SANTA MONICA MOUNTAINS CONSERVANCY

October 23, 2006

**Comments on CUP-S-432 Light Industrial Park
Alamos Creek and Arroyo Simi Confluence**

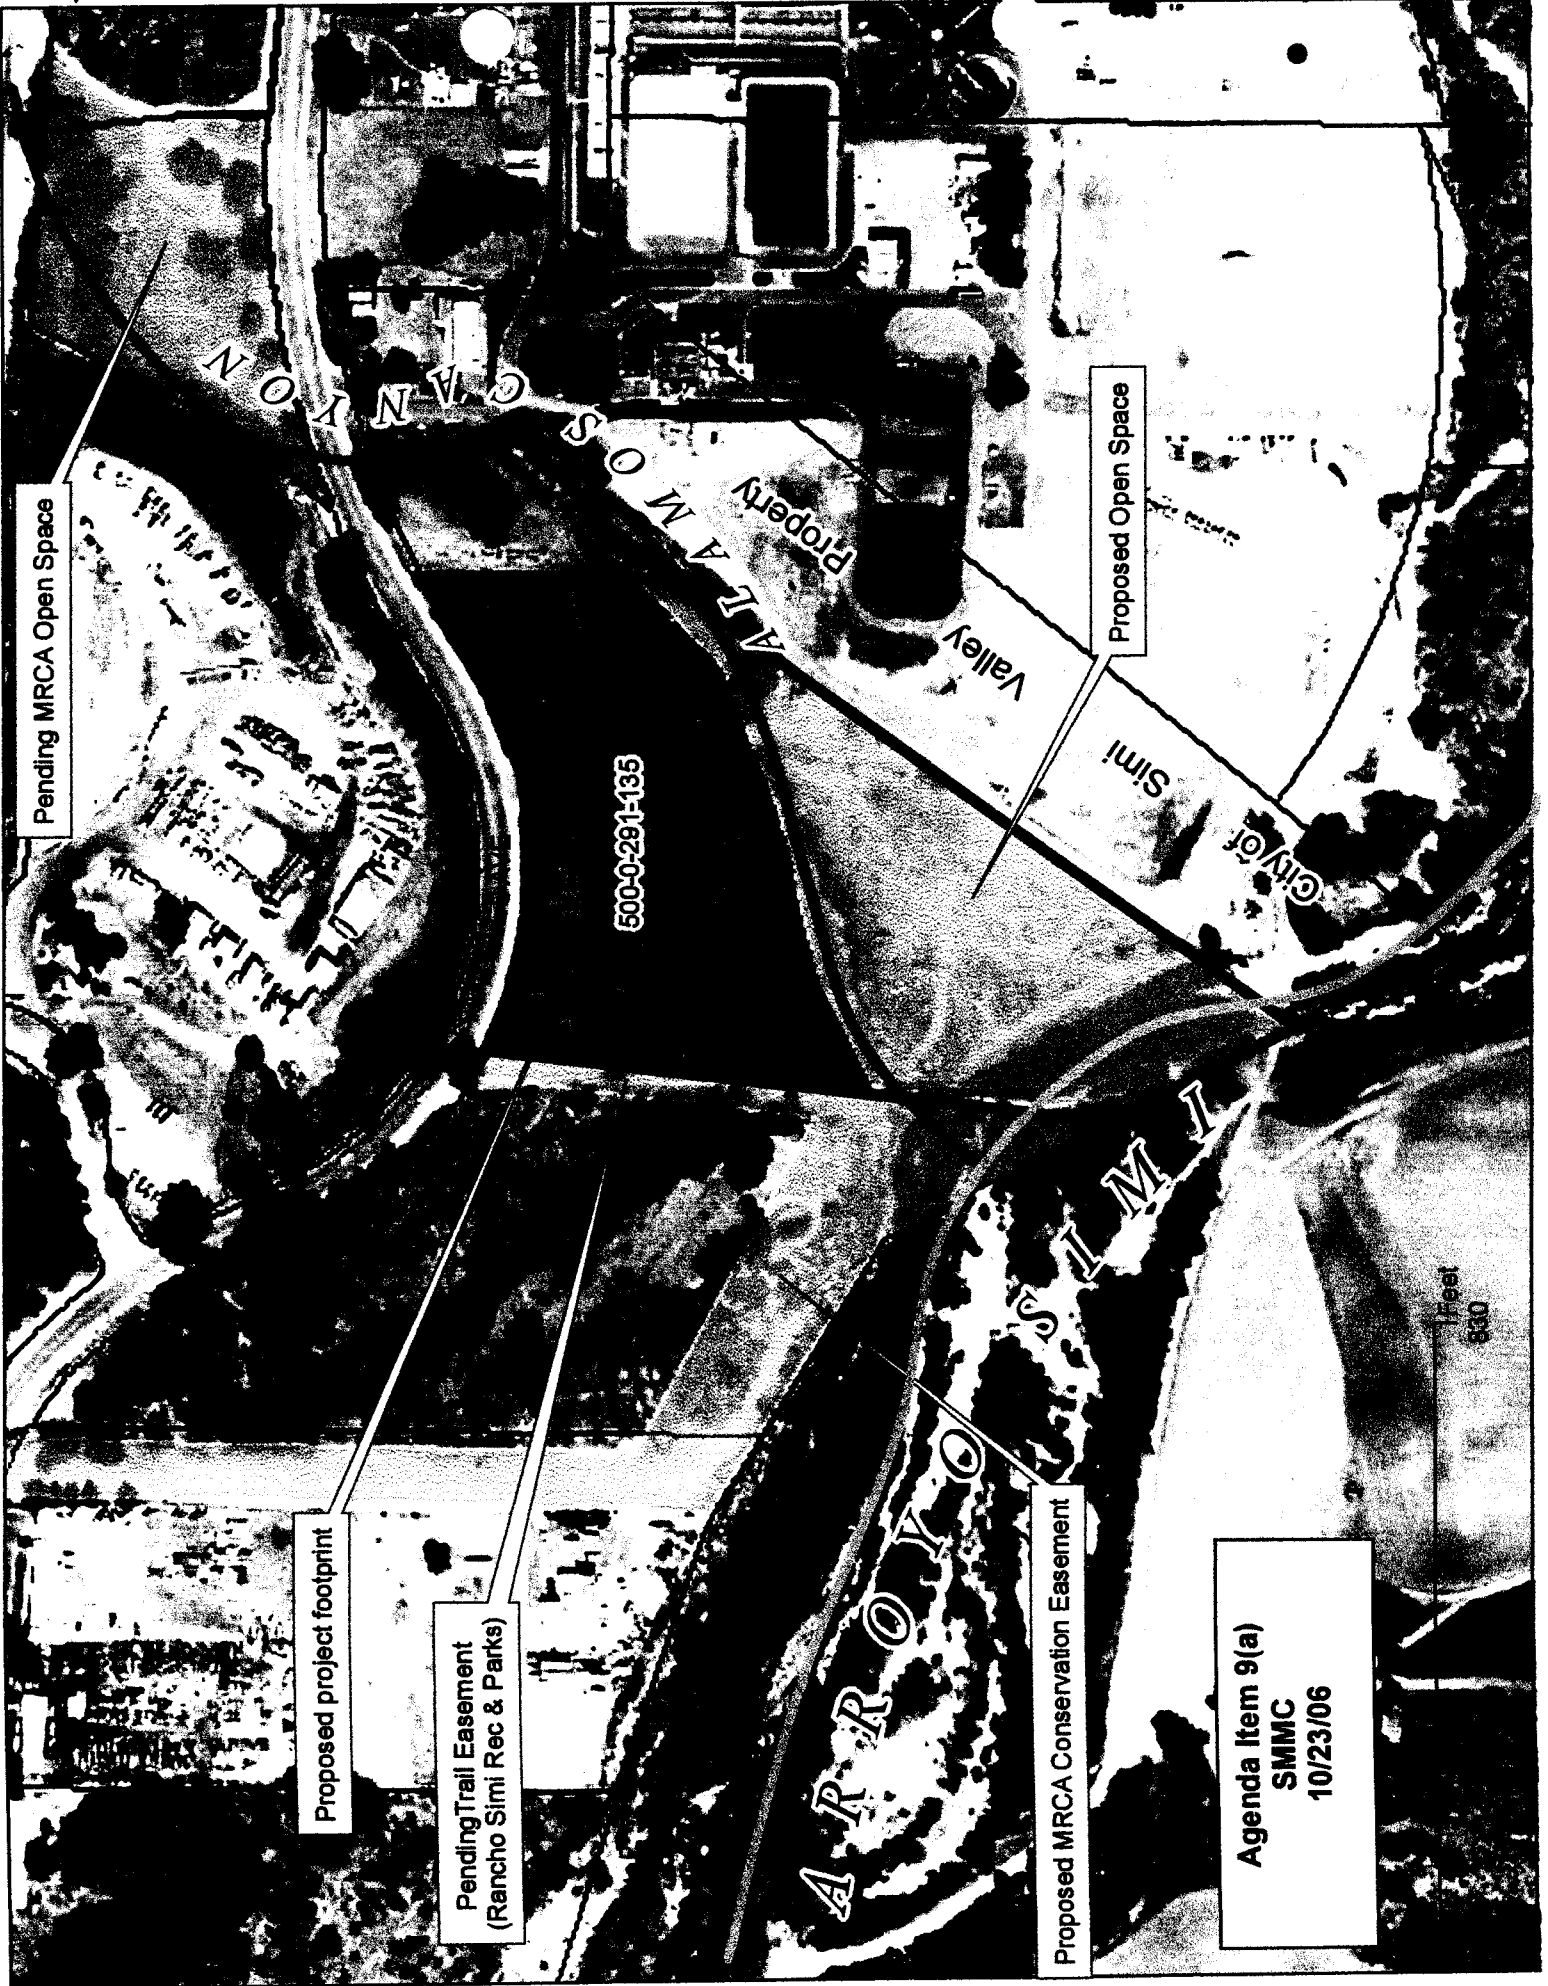
The most significant narrowing of the existing habitat linkage occurs where the Alamos Creek channel transitions from City-owned property to the subject property. As depicted on the site plans, in this location both the existing storage yard on the subject property and

the City property are fenced approximately 30 feet from the centerline of the channel. Thus an approximately 250-foot-long section of the wildlife corridor is constricted to an approximate width of 60 feet because of fencing.

To achieve an adequate wildlife corridor contribution from the subject property, we recommend first that all of the land currently shown on the version of the plans dated July 2006 that is not within the fenced area, or limits of grading, be permanently protected by a conservation easement to the MRCA. That easement would prohibit all uses except up to 30 feet of brush clearance. Secondly, that the permanent disturbance footprint of the proposed project be moved sixty feet away from the shown creek line (dashes and dots) from the eastern project boundary to a point 180 feet south-southwestward of that project boundary. That sixty-foot-wide buffer would include no rip-rap or fencing and would also be protected by a conservation easement to the MRCA.

For the next hundred feet of creek line downstream from this point, the permanent disturbance footprint of the proposed project should be moved forty feet away from the shown creek line (dashes and dots) from the diagonal project boundary. That forty-foot-wide buffer would include no rip-rap or fencing and would also be protected by a conservation easement to the MRCA.
